MCINTOSH MR78

The following are the instruction to convert a tuner from American Standard to European Standard.

OUTPUT AMP PC BOARD 044-794

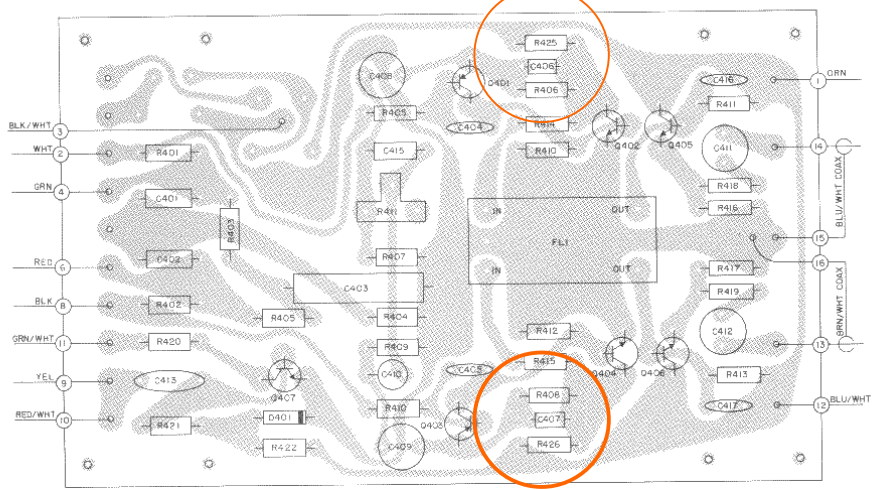
To change de-emphasis from 75 μ s to 50 μ s it is need to replace two capacitors, called C406 and C407 from 1500pF to 1000pf or 1100pF.

The capacitors are located on Output Amp Section accessible from the low cover.

Use a film capacitor, such as polystyrene or polypropolene type.
